# **Review of groundwater pumping related impacts on Reach 1b of Boundary Creek**

**Boundary Creek, Big Swamp  
and Surrounding Environment  
Remediation and Environmental  
Protection Plan**

**December 2022**

## Potential impacts to Reach 1b

Figure 1-1 Predicted drawdown in the LTA in 2010 in the absence of climate effects (Jacobs, 2018a)

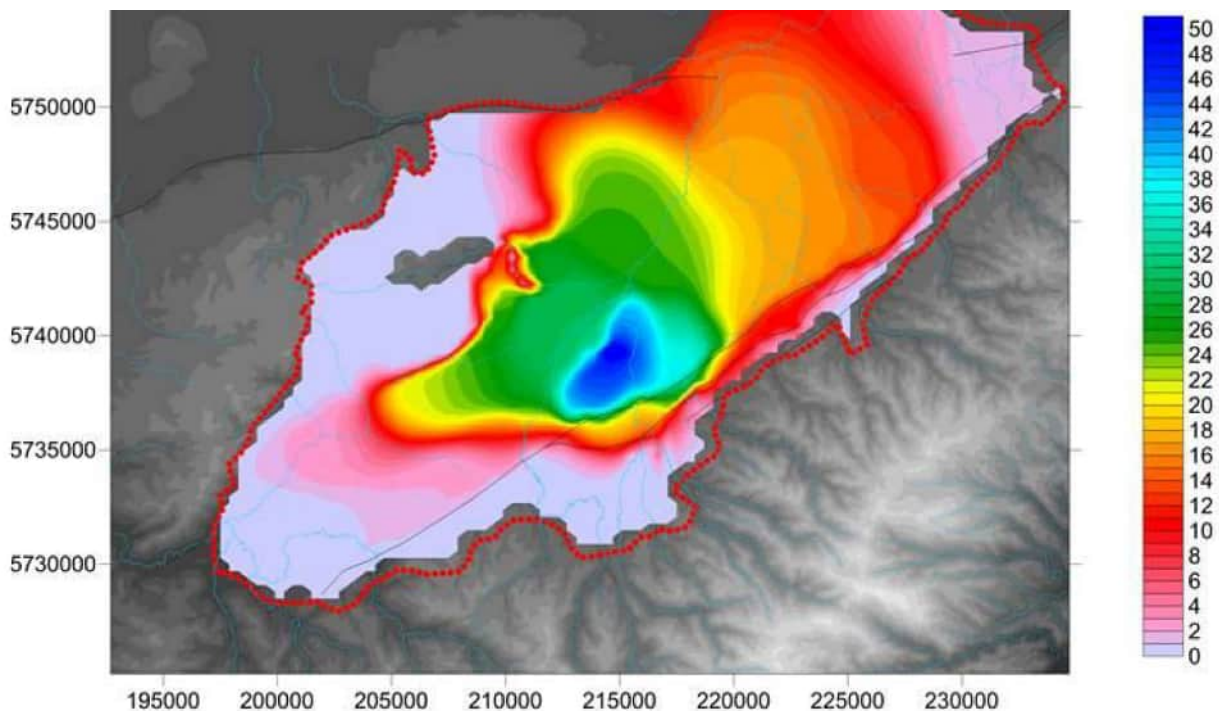
As highlighted in comments provided by the ITRP, the regional groundwater model outputs suggest the potential for borefield related drawdown to have occurred along Boundary Creek in Reach 1b. This is illustrated in Figure 1-1 below which suggests borefield related drawdown increases from 0 m immediately downstream of the basement to ~10 m immediately downstream of McDonalds Dam.

The reach in question is located on the very edge of the predicted drawdown cone. This is driven by the termination of the Pember Mudstone and Pebble Point formation in this region, as well as the thinning of the Dilwyn Formation from 50 m thickness to 1 m thickness (see Figure 1-2 to Figure 1-4 below). Given this, the model results will be dependent on the reliability of the geological surfaces that define the extent and thickness of these units in this area.

Given this, while there is high confidence in the occurrence of the LTA along Boundary Creek at bore 109130 and ~400 m to its south at bore 109136, there is less confidence in its occurrence/thickness immediately upstream of McDonalds Dam at bores 109140 and 109139. As such, there is commensurate uncertainty in the magnitude of drawdown predicted by the model in this area.

**Figure 1-5 Potentiometric surfaces in the LTA (Jacobs, 2017)**

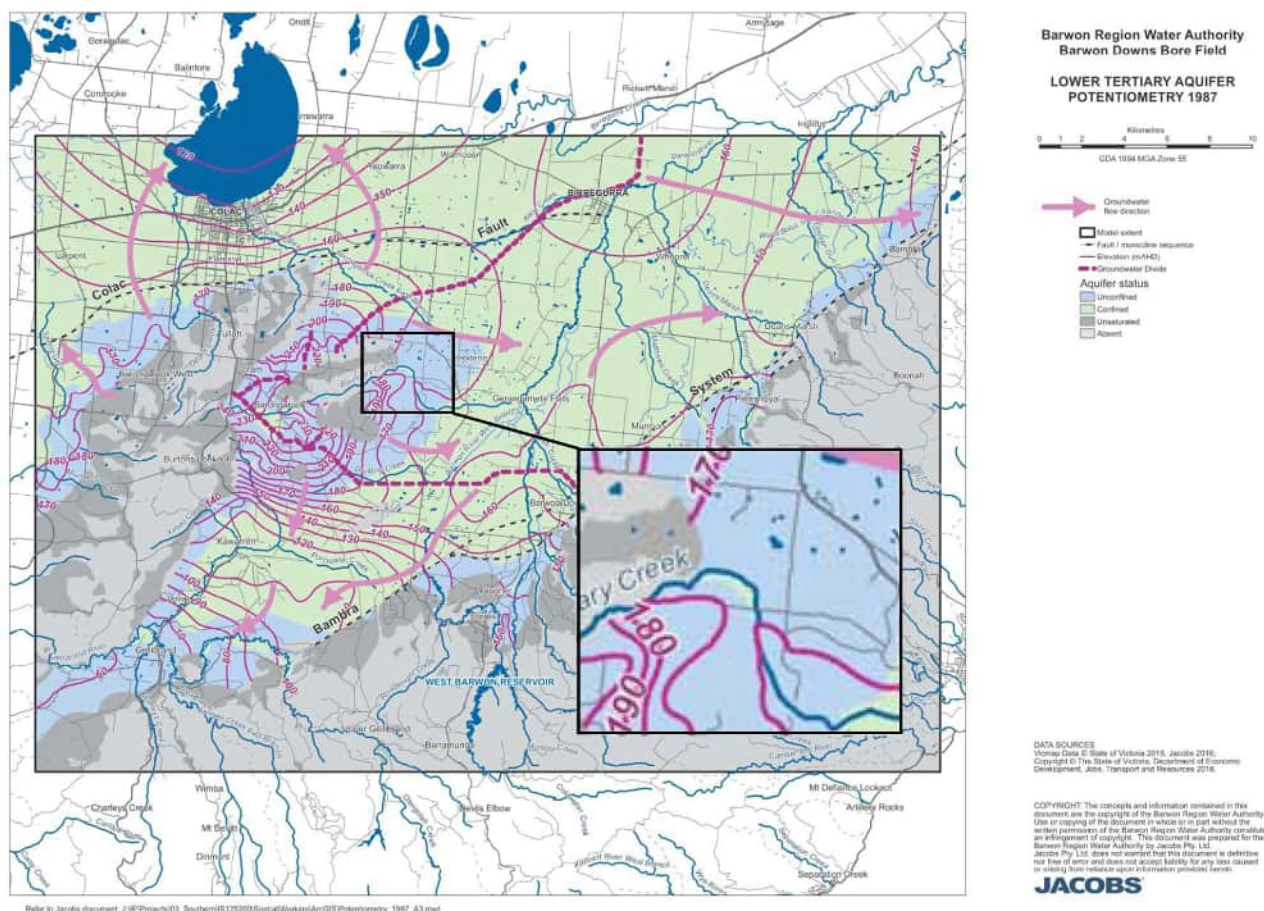
The ITRP have highlighted that potentiometric surfaces in the LTA show that Reach 1b was previously a gaining stream (i.e. contours 'bent' around the stream alignment and pointing upstream), and that it is not so now. The potentiometric map for 1987 referenced by the ITRP is illustrated in Figure 1-5 below, with an enlargement of Reach 1b provided.

Firstly, and as highlighted above, the potentiometric surfaces generated for Reach1b are subject to the same uncertainty driven by the occurrence/thickness of the LTA upstream of bore109130. Secondly, and as illustrated in the enlargement below, the 160 m AHD contour only crosses Boundary Creek downstream of McDonalds Dam in Reach 2a. As such, the potentiometric surface presented only suggests that Reach 2a of Boundary Creek was gaining in 1987, not Reach 1b.
